# Penn Reel Parts list for Model: SSV6500BLS Spinfisher V Bail-less

## MYSTIC REEL PARTS REVISION!

**MRP Ver 032924 (Parts List updated to clarify housing/gearing design changes sizing)**

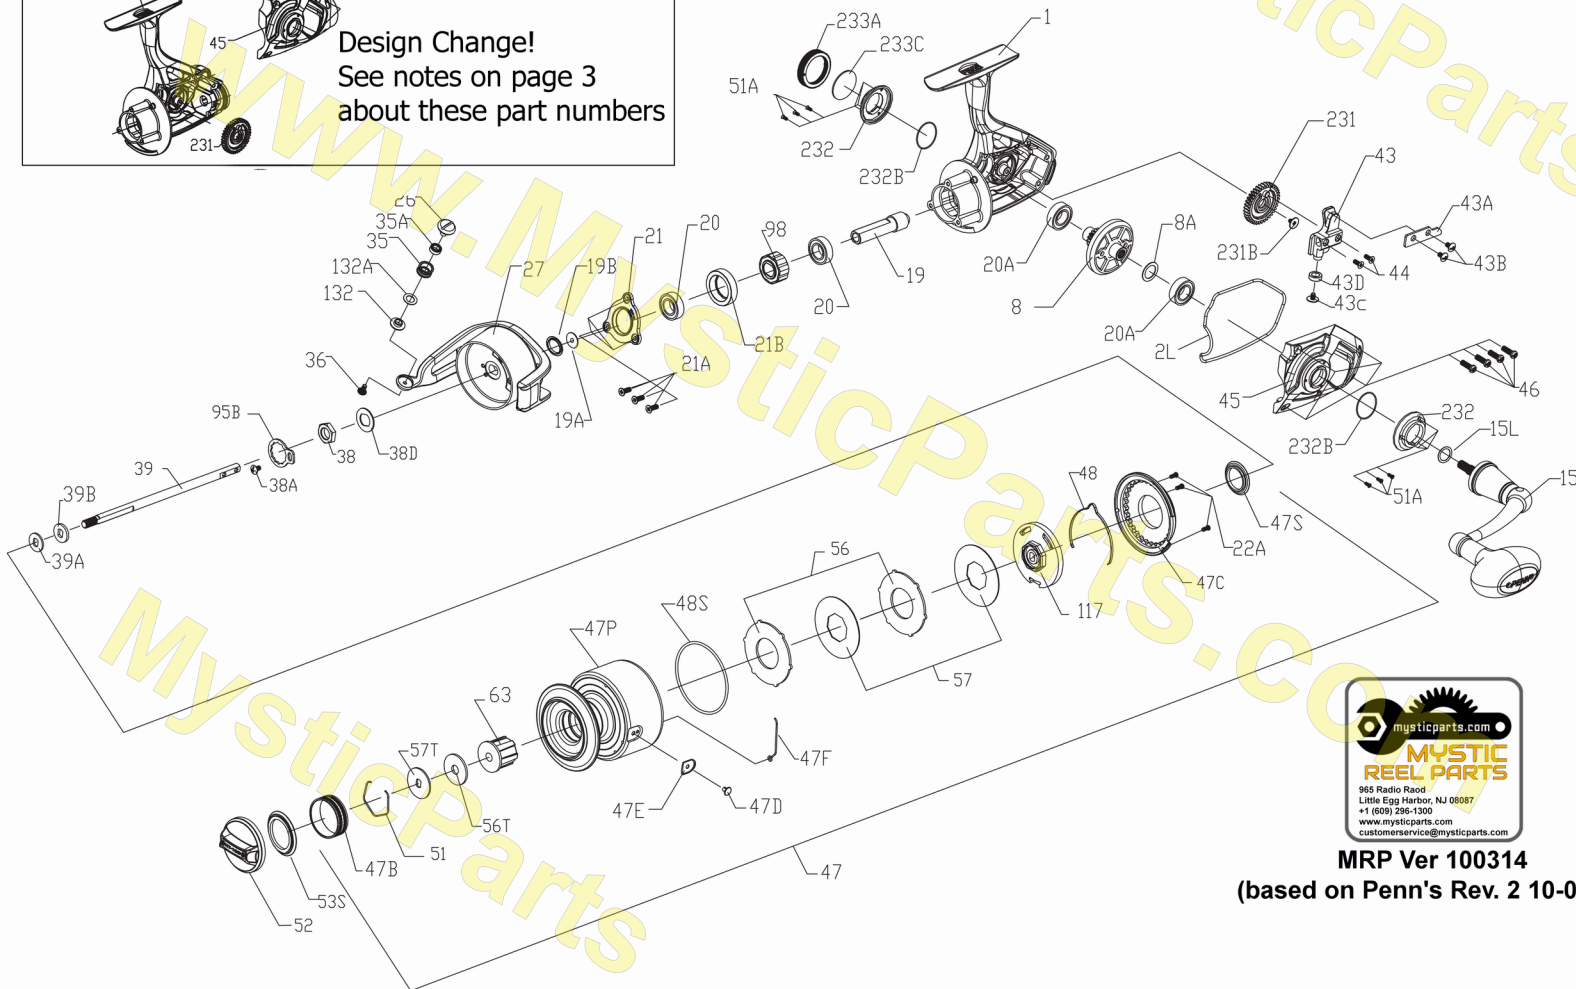
Design Change!  
See notes on page 3  
about these part numbers

<b>*****Design change after first run</b>				1	1313703	1-SSV6500BLS	HOUSING, BODY ASSEMBLY with .23 peg
Early SSV6500BLS run had a slightly different housing and crosswind gear				231	1277098	231-SSV5500	CROSSWIND OSCILLATION GEAR 0.23" I.D.
The diameter of the hole in the crosswind was almost 3/8". Later runs, the crosswind gear and the pin in the housing that it sits on must have been changed.				45	1314299	45-SSV6500BLS	HOUSING / BODY COVER
The current gear I.D. is .23" just under 1/4", current housing matches it.				1	n/a	1-SSV6500BLS	HOUSING, BODY ASSEMBLY with .309 peg
<b>Current = Pennparts.com inventory from Penn as of 10/3/14</b>				231	n/a	231-SSV6500LL	CROSSWIND OSCILLATION GEAR 1st run 0.309" I.D.
				45	n/a	45-SSV6500BLS	HOUSING / BODY COVER

<b>***** DESIGN CHANGE WARNING *****</b>				<b>MEASURE and CHECK STOCK FIRST! .23 peg (1/4") SIZE</b>			
Early SSV reels when released had a slightly different housing, crosswind gear and housing cover				1	NLA **	1-SSV6500BLS	HOUSING, BODY ASSEMBLY with .23 peg (1/4")
The diameter of the CW gear hole and post was CHANGED				231	NLA **	231-SSV5500	CROSSWIND OSCILLATION GEAR 0.23" I.D. (1/4")
and the pin/pin hole diameters on the 45- cover were changed as well				45	NLA **	45-SSV6500BLS	HOUSING / BODY COVER to match (1/4")
THIS DESIGN CHANGE affects the housing, crosswind gear, and housing cover				231B	1307857	231B-SSV3500	CROSSWIND OSCILLATION GEAR SCREW (1/4")
				<b>NOTE: We never received or saw anything for this SSV6500BLS reel in 1/4" 2014 - 2024</b>			
<b>MEASURE YOUR HOUSING/GEAR</b>				<b>MEASURE and CHECK STOCK FIRST! .309 peg (5/16")</b>			
At the post where the crosswind sits or the hole in the center of the crosswind gear.				1	1313703	1-SSV6500BLS	HOUSING, BODY ASSEMBLY with .309 peg (5/16")

231	1277098	231-SSV5500	CROSSWIND OSCILLATION GEAR 1st run 0.309" I.D. (5/16")
<b>Parts that you order MUST MATCH EACH OTHER</b>				45	1314299	45-SSV6500BLS	HOUSING / BODY COVER to match (5/16")
<b>Some parts may no longer be available, so check all three parts for availability and matching size</b>				231B	1277100	231B-SSV5500	CROSSWIND OSCILLATION GEAR SCREW (5/16")
<b>***** BEFORE YOU PLACE AN ORDER! *****</b>				<b>** NLA = NOT AVAILABLE as of 2024 updates (design changes were first noted back in 2014)</b>
